**TOWN OF WESTWOOD
COMMONWEALTH OF MASSACHUSETTS**

**INVITATION FOR BIDS
Westwood High School Practice Field
Bid # DPW-22-B-023
Addendum 01
March 30, 2022**

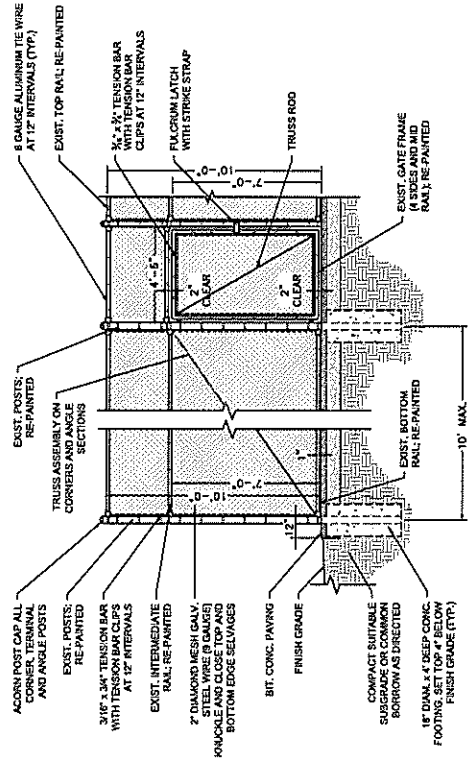
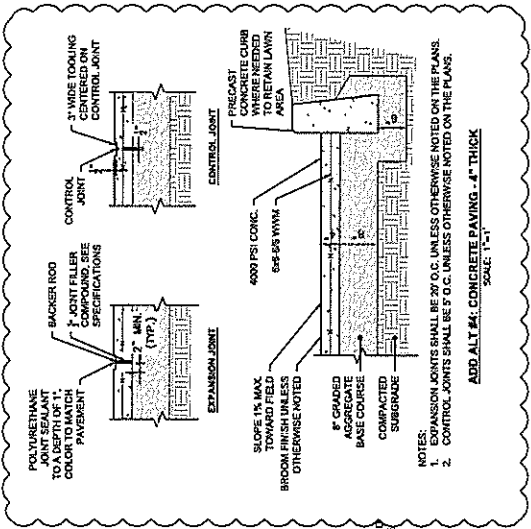
- Q2 How will the grade be handled at the back of the concrete pads (Add Alternate #4) where it will end up above the grade of the concrete pad?
A2 Where the grade at the back of the concrete pad is less than 6", the grade should be gently sloped to meet the existing lawn area and re-seeded. Where the grade at the back of the concrete pad is 6" or more, a pre-cast concrete curb shall be used to retain the grade. See Addendum 01b (former sheet 8 in bid set).

- Q3 How should the concrete pads be pitched for drainage (Add Alternate #4)?
A3 The concrete pads should be pitched a minimum of 1% towards the track due to the grades of the lawn area. See Addendum 01b (former sheet 8 in bid set).
